Project
Newsome Ponds, Huddersfield

Title
Existing Pond Sections sheet 1

Project number	Originator	Volume	Level	Type	Role	Drg. No.	Rev.
24.21001	ACE	ZZ	ZZ	DR	S	3005	P3

S1 Existing Pond Section 1

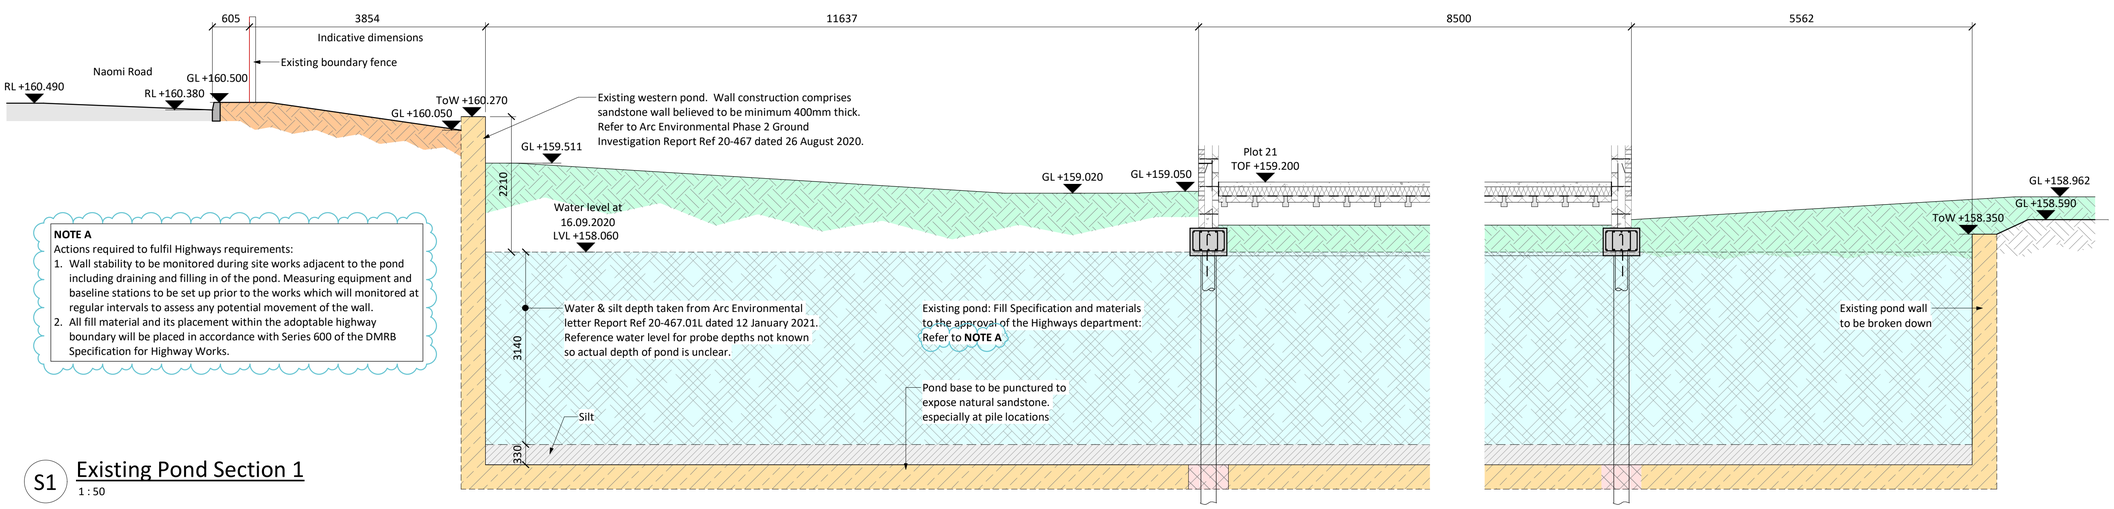
Date	Description	By	Chk	Rev
16.03.22	Notes added as clouded	WRH	PG	P3
11.02.22	Updated FFLs to Plots 1-3, pond sections revised to suit, as clouded	WRH	TH	P2
07.02.22	First Issue	WRH	TH	P1

NOTE A
Actions required to fulfil Highways requirements:
1. Wall stability to be monitored during site works adjacent to the pond including draining and filling in of the pond. Measuring equipment and baseline stations to be set up prior to the works which will monitored at regular intervals to assess any potential movement of the wall.
2. All fill material and its placement within the adoptable highway boundary will be placed in accordance with Series 600 of the DMRB Specification for Highway Works.
